Interactive comment on “Runoff formation from plot, field, to small catchment with shallow groundwater table and dense drainage system in agricultural North Huaihe River Plain, China” by S. Han et al.

S. Han et al.

Received and published: 20 June 2012

Fig. 1. Figure R1. Relationship between estimated available water storage and initial water table depth

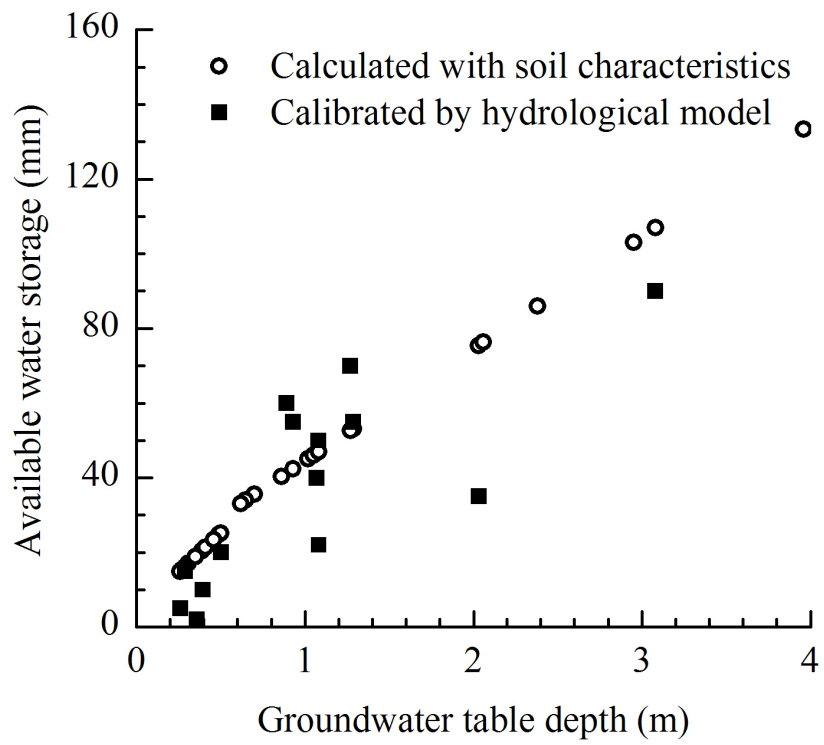
1. The paper should stress out that groundwater table as a wetness indicator is a

proxy only to the soil moisture status. Rough estimation of the available water storage towards the accumulation availability of the water in the vadose zone is advised based on simple tools as retention curve derived e.g. from particle size properties assuming equilibrium distribution of the soil water content along vertical axis, if measured data are not available.

It is a helpful advice to calculate the available water storage before each event. But the relationship between the water table depth and soil moisture dynamics is complicated. In order to give a roughly comparison, the differences between saturation water content and field capacity was used to calculate the available water storage. In the study area, the soil was divided into three layers according to its characteristics: 0~20cm with saturation water content and field capacity 39.6% and 30.7%; 20~50cm with saturation water content and field capacity 30.1% and 25.8%; 50cm~400cm with saturation water content and field capacity 28.1% and 25%. The plots of calculated available water storage and water table depth are shown in Figure R1.

At present, the Xinanjiang model (a lumped conceptual rainfall–runoff model) (Zhao, 1992) was used to simulate the storm-runoff processes of 14 events at the catchment with calibrated parameters (including averaged soil moisture storage capacity of three layers) and antecedent soil moisture content. The performances of the model were acceptable (with Nash-Sutcliffe efficiency around 0.7). The difference between averaged soil moisture storage capacity and antecedent soil moisture content can be served as available water storage. And it was also plotted against the water table depth of the 14 events in the figure.

Although the calculation at present is not very precise, it is obvious that available water storage is closely correlated with initial groundwater table depth. Groundwater table can be served as a wetness indicator. In the revised manuscript, we will state clearly that the groundwater table data is served as a proxy to the soil moisture status. We will continue the study on the relationship between groundwater table and soil moisture status.
